SUBJECT: ISSUANCE OF AMENDMENT NO. 11 TO FACILITY OPERATING LICENSE NPF-68
VOGTLE ELECTRIC GENERATING PLANT, UNIT 1 (TAC 68164)

AMENDMENT NO. 11 TO FACILITY OPERATING LICENSE NPF-68 - Vogtle Electric
Generating Plant, Unit 1

Amendment No. 11
License No. NPF-68

ATTACHMENT TO LICENSE AMENDMENT NO. 11

FIGURE 3.1-1 REQUIRED SHUTDOWN MARGIN FOR MODES 3 AND 4 (MODE 4 WITH AT LEAST ONE REACTOR COOLANT PUMP RUNNING)

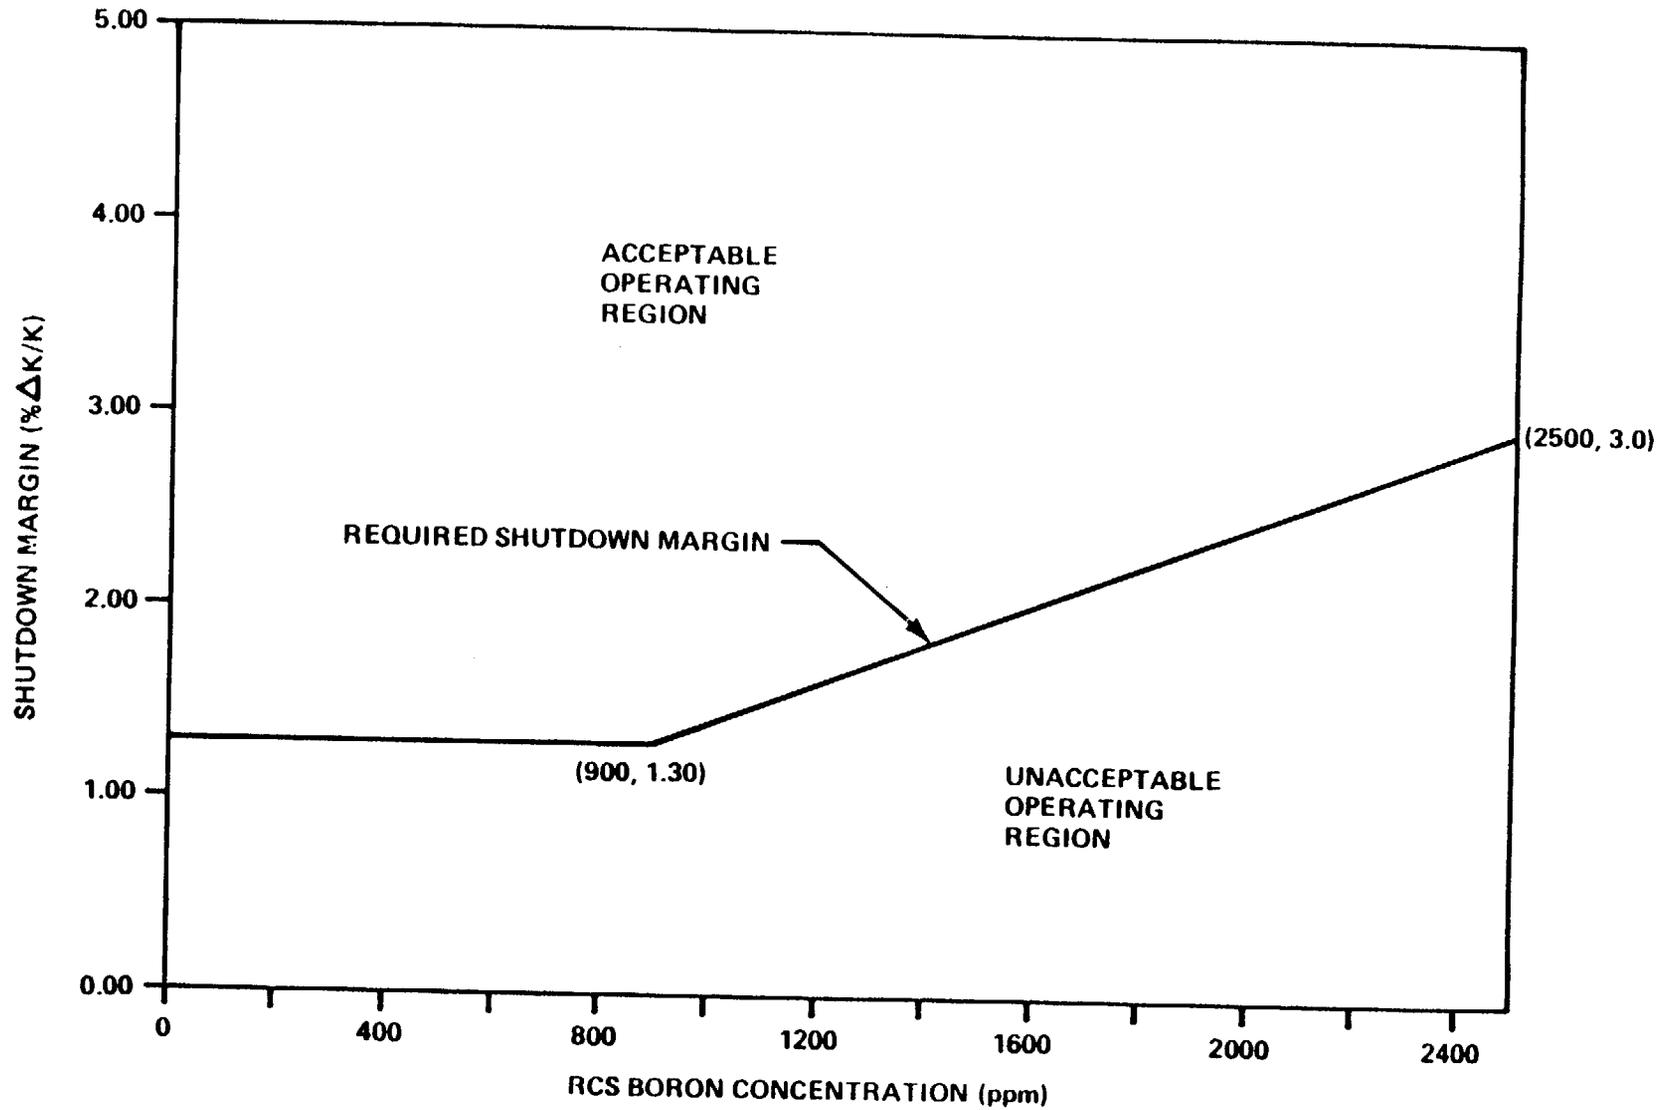
By letter dated May 19, 1988 (Ref. 1), Georgia Power Company (the licensee) made application to amend the Technical Specifications of Vogtle Electric Generating Plant, Unit 1 (Vogtle 1). The proposed changes would modify the Technical Specifications (TS) concerning (1) the moderator temperature coefficient (MTC) and (2) shutdown margin (SDM) requirements. The MTC change would allow a slightly positive MTC below 100 percent of full rated power. The principal benefit of this change is that it would facilitate the design of future reload fuel cycles. TS changes are required to meet SDM requirements to accommodate the positive MTC and future 18 month reload fuel cycles. To assure that subcriticality requirements are met following a postulated loss-of-coolant accident (LOCA), the boron concentration is increased for the refueling water storage tank (RWST) and the accumulators. An increase in the RWST water volume requirement for Modes 5 and 6 is also proposed. To meet subcriticality requirements for boron dilution events, the SDM limits for Modes 3, 4, and 5 and the high flux at shutdown alarm setpoint are changed.
